2129 Lanesborough Outdoor Theatre
Commons North,
Co. Longford

RESPONSE TO SUBMISSIONS

Request for Further Information

DE BLACAM AND MEAGHER

Figure 4: Revised Proposed Landscape Plan

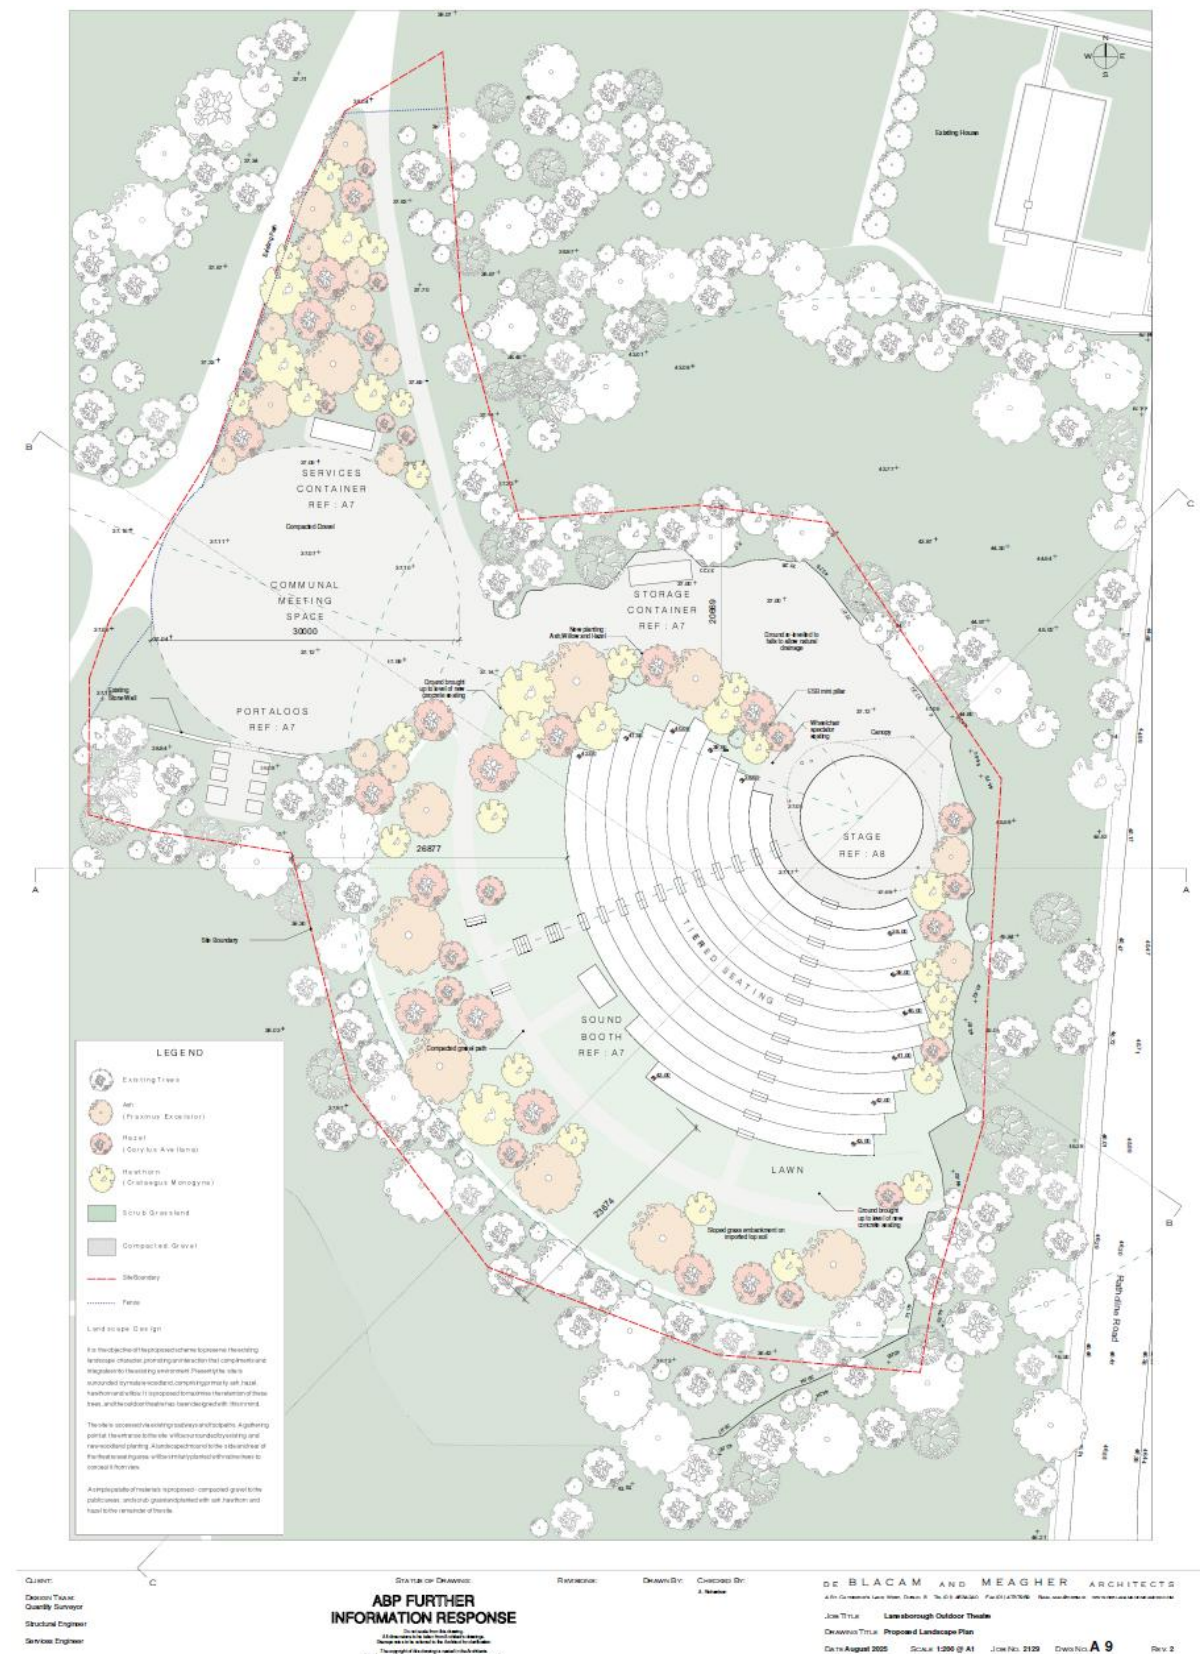
Observation: "The site plans are unclear with regards to the addition of trees to the top of the quarry face. Similar to point 1, if the planting of new trees is proposed on the top of the quarry face, this is neither sustainable nor warranted. The potential addition of trees to the top of the quarry face will pose a safety and environmental risk to patrons using the proposed facility in terms of debris, falling limbs, and even falling trees due to both the topography of the site and potential for adverse weather events in the area."

Response: There are no trees proposed to be planted at the top of the quarry face on the eastern side. All proposed planting is to be to the landscaped area within the boundary lines which are below top of quarry level.

The planting proposal made at planning stage has been revised as below. (See figure 4). This will be further progressed and designed by a Landscape Architect. Having considered the above observation, we have revised the planting proposal to relocate any tree planting to the lower section of the amphitheatre mound to ensure that it does not impact unreasonably on existing views.

DRAWING TITLE Obscured View Zones - House 3

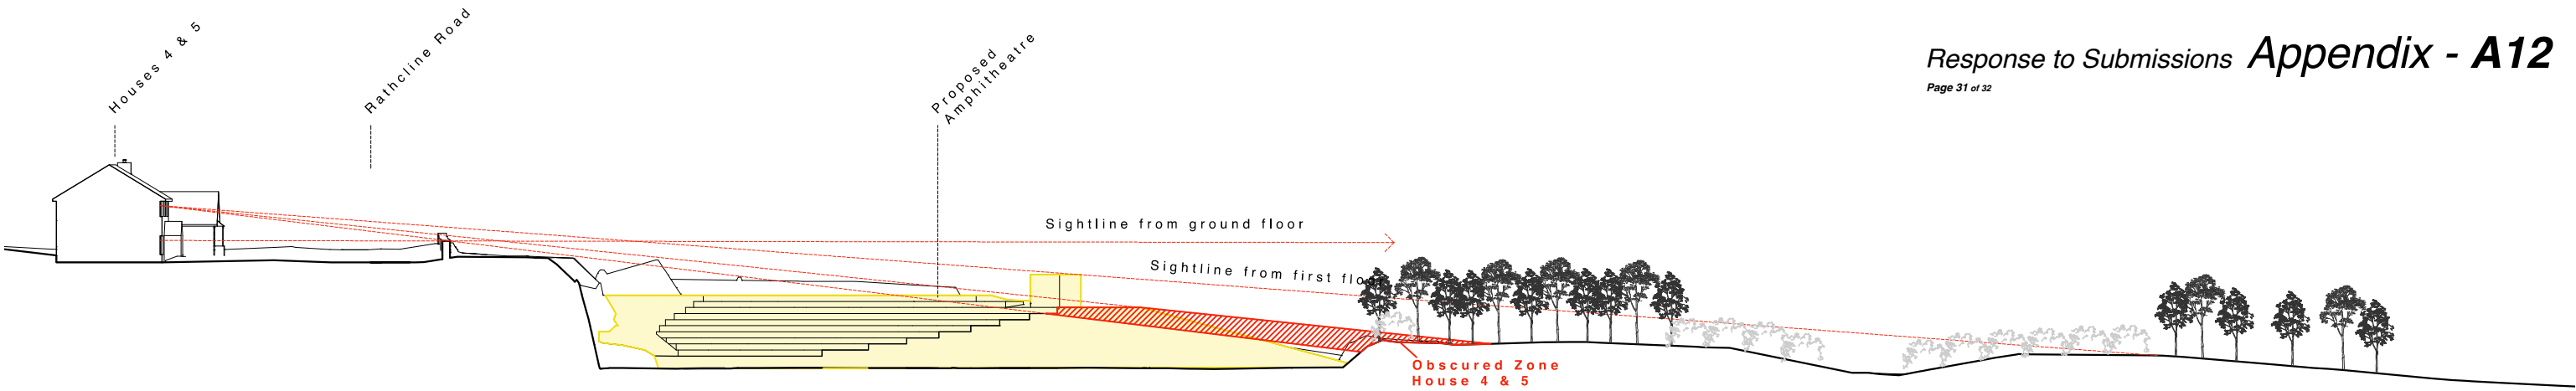
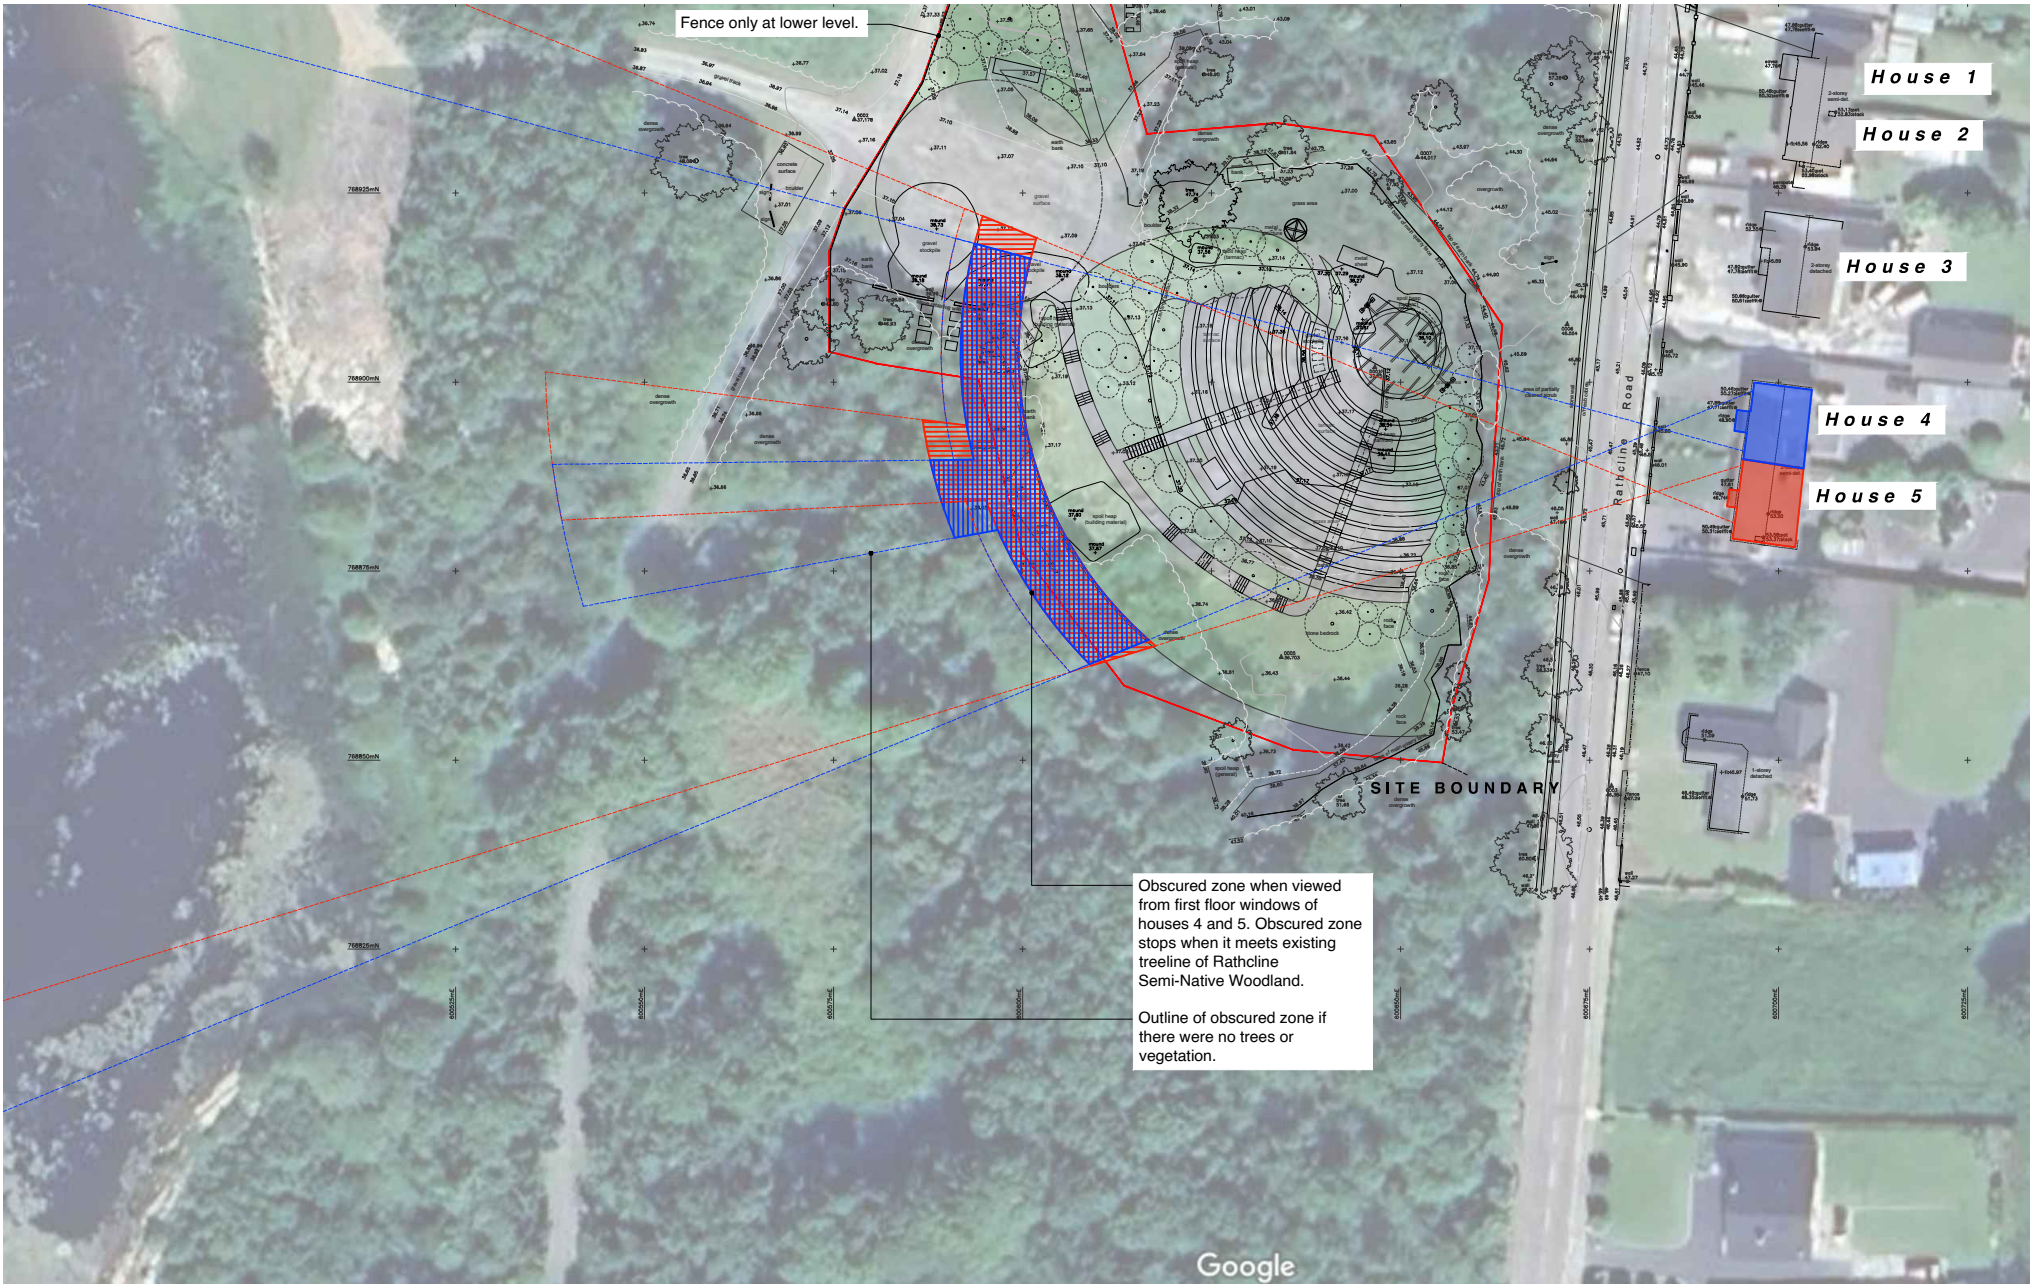
Observation: “The height of the proposed amphitheatre structure is 6 metres plus above ground level with an extensive embankment area at the top. In addition, a proposed sound booth is situated at the top of the structure at a combined height of the 8.5 metres.

1(c). Obstruction to view over Commons North, Lough Ree and River Shannon from Rathcline road and my property.

1(c). While the upper 2 tiers and sound booth of the amphitheatre will be visible, it will make minimal impact in the overall context of the Rathcline Semi-Native Woodland and Recreation Area. Considering shrubs at the top of the quarry and the woodland below, the impact on views from the property will be minimal in the overall context.

Refer to drawing **A13** in the Appendices.

An illustration of the zone which will be potentially obscured by the amphitheatre can be found on drawing **A13** in the Appendices.

DRAWING TITLE Obscured View Zones - Houses 4 and 5

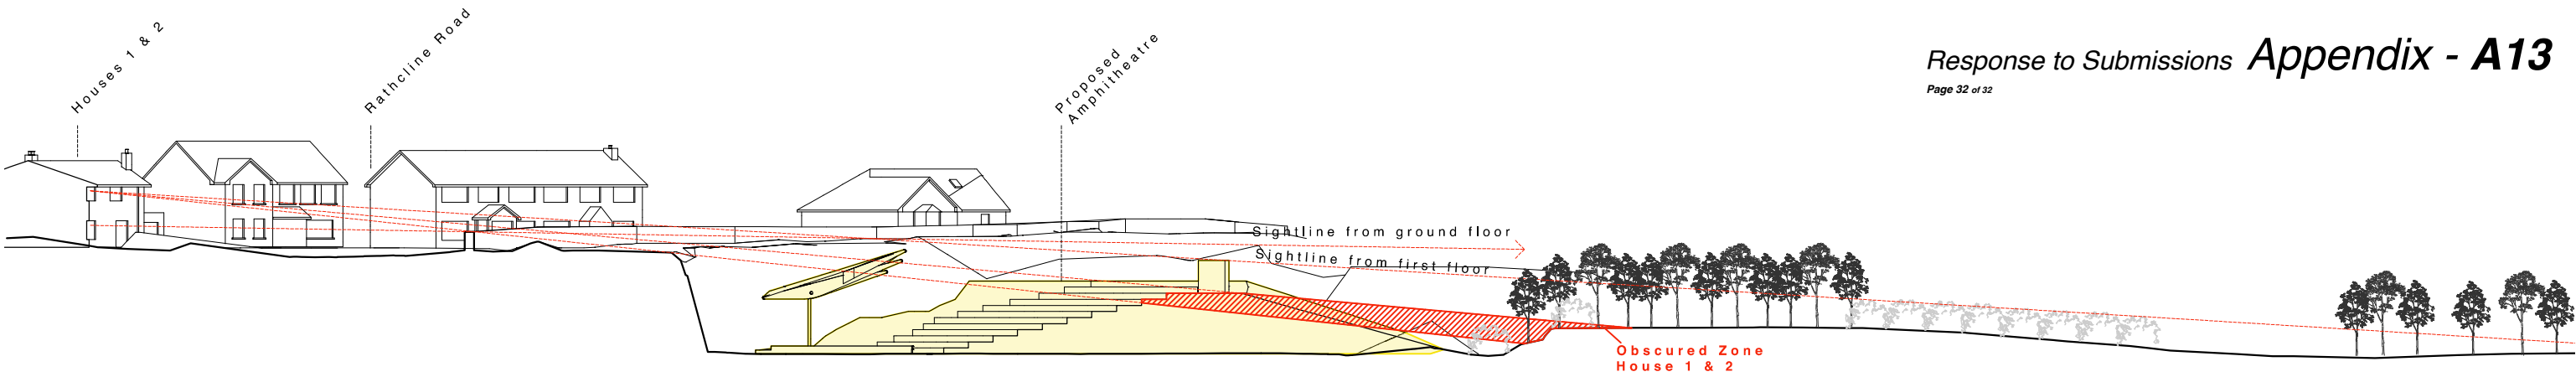
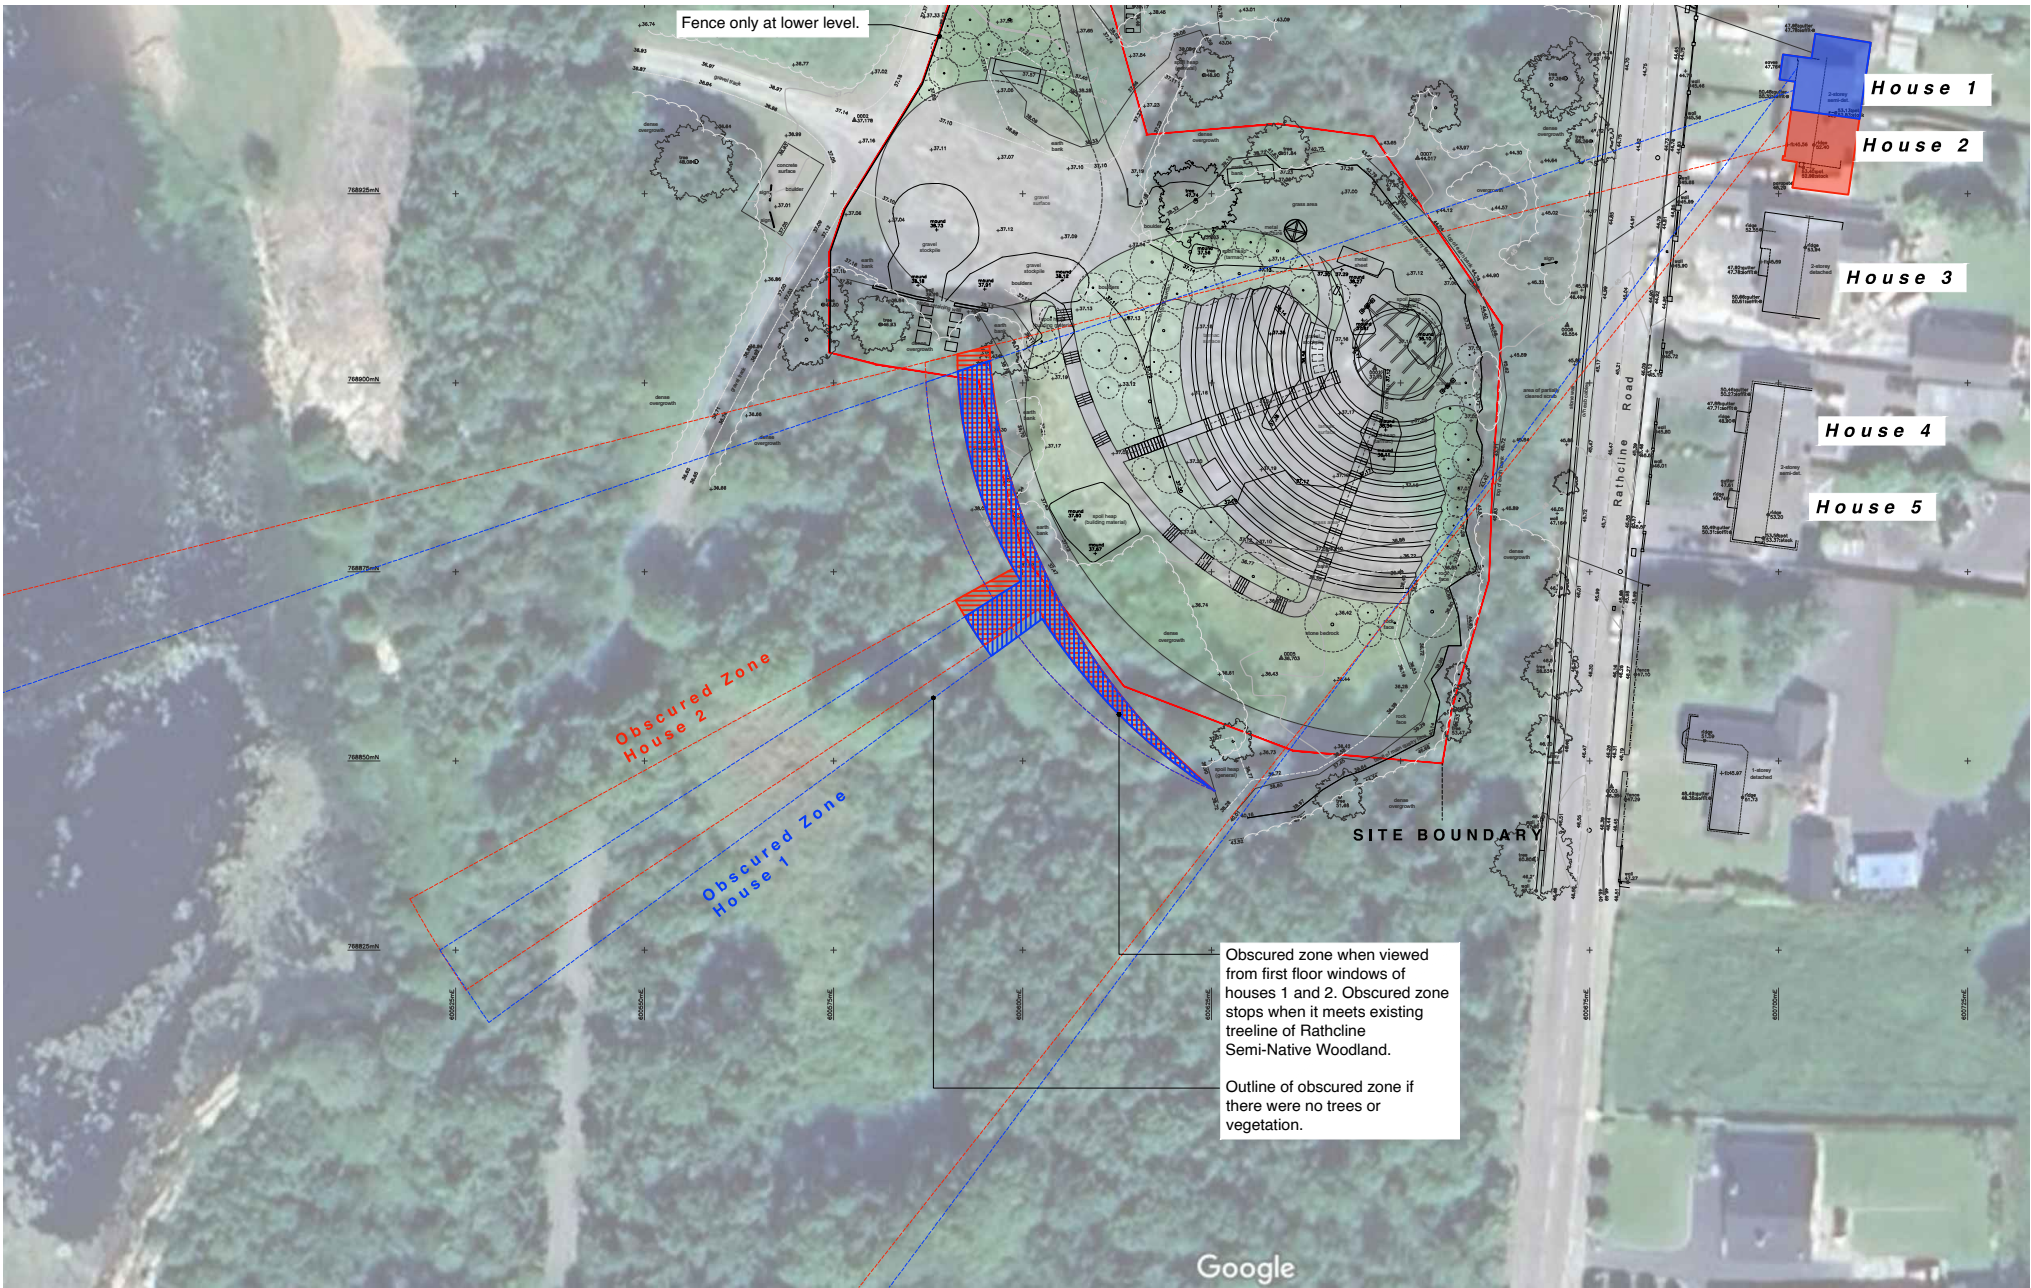
Observation: “A three-meter high fence to the perimeter of the structure, is outlined in three reports attached to the planning application by Flynn Furney (Environmental assessment page 5, Assessment screening page 14 and Natura impact statement page 22).

Response: There will be no fence at high level along the quarry edge. The proposed perimeter fencing will be to the Western side of the boundary line. Refer to drawing **A12** found in the Appendices.
